Introduction

These comments relate to an outline planning application for up to 500 homes.

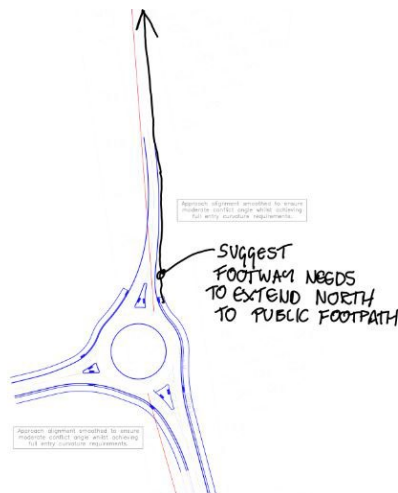
A pedestrian connection needs to be added to provide a link to Footpath 265/36/10 east of Upper Campsfield Road. This footpath extends around the perimeter of London-Oxford Airport providing potential links to Oxford Spires Business Park, Thrupp and a wider network of recreational routes including the Oxford Canal.

I support a pedestrian route to the perimeter of the development area however I question whether it should be specified as a 2m hoggin path at this stage. At the detailed design stage, it may be considered appropriate to have a combination of edge lanes and connecting paths. I suggest the parameter plan is amended to allow for a combination of edge typologies.

I have illustrated these points on the mark-up below.
